## **Amendments to ECE/TRANS/WP.29/GRSP/2021/28 (UN Regulation No. 127)**

### **Submitted by the expert from OICA**

### **I. Proposal for the 03 series of amendments to UN Regulation No. 127 (Pedestrian Safety)**

"Figure 5

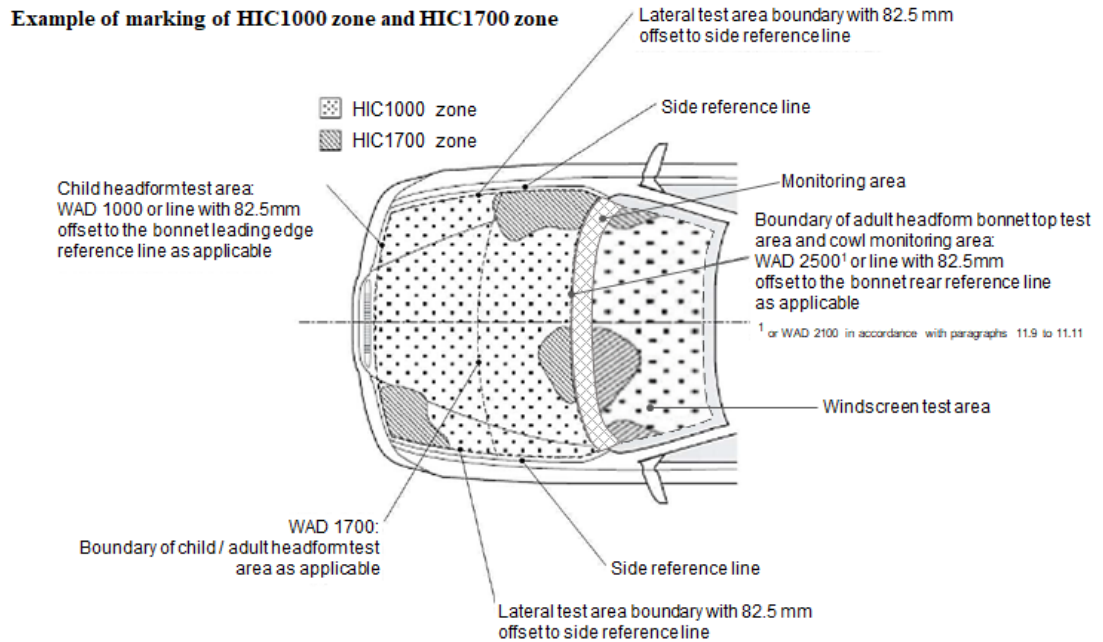
Annex 5, Figure 5., replace by:
